BS-RS and RS-RS LOS Multihop Path Loss Model

IEEE C802.16j-06/062

To further clarify the LOS path model for BS-RS, RS-RS and comparison with WINNER model

RS above rooftop: Path loss plots

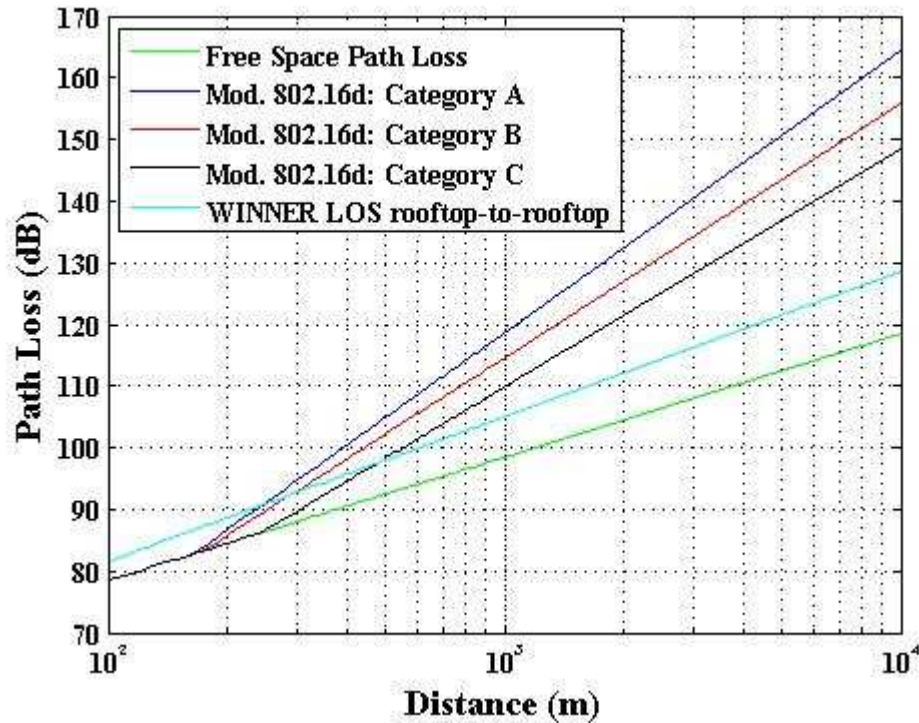
- For this scenario the RS is assumed to be above the rooftop and have a LOS back to the BS. The WINNER model is based on measurements at 2.5GHz using the parameters given above. It is close to free space loss and represents a good model for this case.
- The IEEE 802.16d model for terrain category C gives similar results for distances up to 1km. It gives higher path loss at distances > 1km, which is realistic due to reduced probability of LOS at larger distances. This may therefore be a better model in terms of predicting interference levels.

- The modified IEEE 802.16d Category C path loss model is similar to the WINNER channel model for distances $< 1\text{km}$
- The WINNER channel model assumes a LOS between the BS and RS.
 - This will not be the case for interfering basestations in a multicell environment
- Recommend using the modified IEEE 802.16d Category C channel model for BS-RS above rooftop links in multicell simulations
